Access Compliance Report Public Rights-of-Way (Curb Ramps)

Main Street: FOSTER_RD Cross Street: COPA_DE_ORO_DR Location: SW

ADA ID: RPRK211207122445 Ramp Type: Type 4 - Parallel Initial Pass/Fail: Fail Overall Compliance: No Severity Score: 30

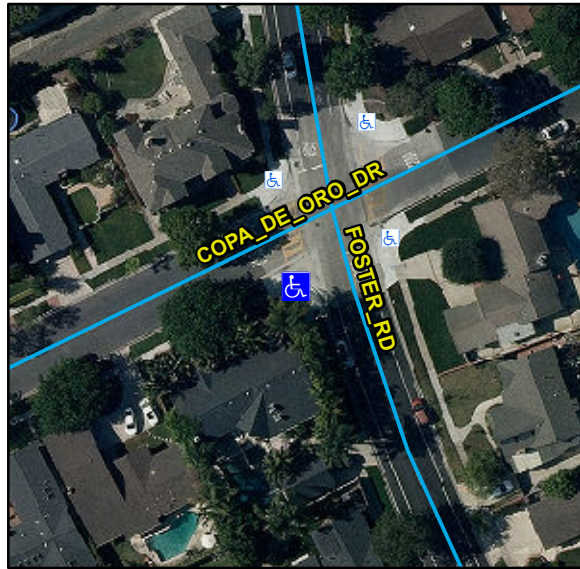
Compliance	Description	Data	Compliance	Description	Data
N/A	Ramp Length LT (in)	89	N/A	Ramp Length RT (in)	89
Yes	Ramp Width LT (in)	81	Yes	Ramp Width RT (in)	81
Yes	Ramp Run Slope LT (%)	0.7	Yes	Ramp Run Slope RT (%)	6.3
No	Ramp Cross Slope LT (%)	3.5	No	Ramp Cross Slope RT (%)	7.6
N/A	Landing Present	N/A	N/A	DWS Provided	N/A
N/A	Landing Length (in)	N/A	N/A	DWS Contrast	N/A
N/A	Landing Width (in)	N/A	N/A	DWS Length (in)	N/A
N/A	Landing Run Slope (%)	N/A	N/A	DWS Full Width	N/A
N/A	Landing Cross Slope (%)	N/A		DWS Offset Type	N/A
N/A	Landing Movement Obstructed?	N/A	N/A	DWS Offset Left (in)	N/A
	Landing Movement Type	N/A	N/A	DWS Offset Right (in)	N/A
N/A	Landing Shared	N/A			
N/A	Clear Space	Yes			
N/A	Clear Space To Crosswalk (in)	N/A			
N/A	Marked Crosswalk 1	No	N/A	Marked Crosswalk 2	Yes
	Crossing 1 Direction	E		Crossing 2 Direction	N
	Marked Crosswalk 1 Width (in)	N/A		Marked Crosswalk 2 Width (in)	144

Remove & Replace Curb Ramp With Two New Directional Ramps or Equivalent.
